Service NOTIFICATION

Coolant hose chafing

SN-LTUL-CT__-03;
SN-LTUL-CT2k-04

TECHNICAL ADVISE No. 4

Fig. 1

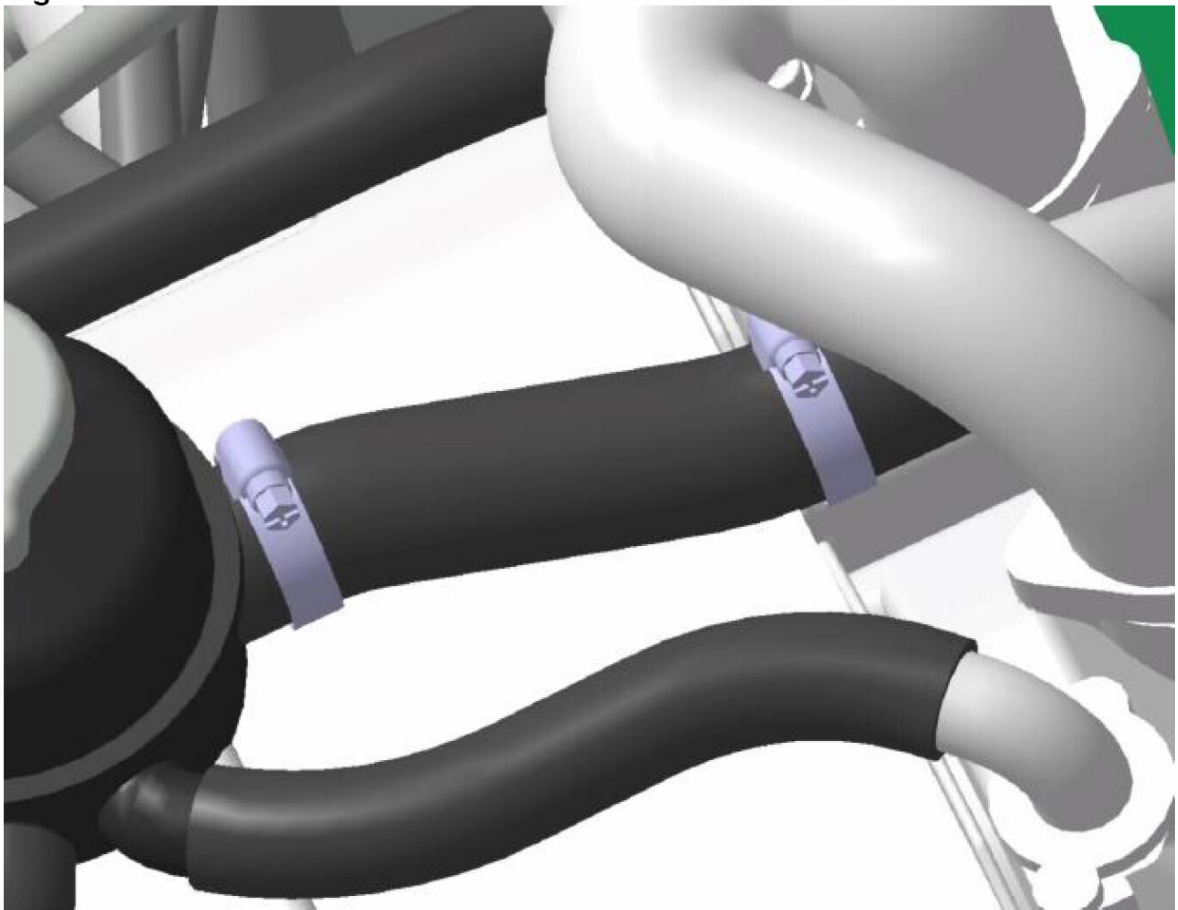
According to information from UK there can be a problem that one of cooling system rubber hose gets worn against cast inlet air manifold of the engine.

Aluminium pipe routed from cooling liquid expansion tank on the top of the engine under left cylinders air inlet manifold (see fig.1) down to radiator was modified to more simple shape utilizing one-plane bends. With that the distance from expansion tank to upper edge of aluminium tube increased from about 2 up to about 7 cm and clamp was moved outside (see fig.2).

Please check if you can see in your plane rubber hose fixing clamp installed outside the air inlet manifold, please check wearing of the rubber hose against the manifold. If the rubber hose is worn out without having an aluminium tube under it and being clamped between manifold and expansion tank, replace rubber hose and the aluminium tube to a longer one.
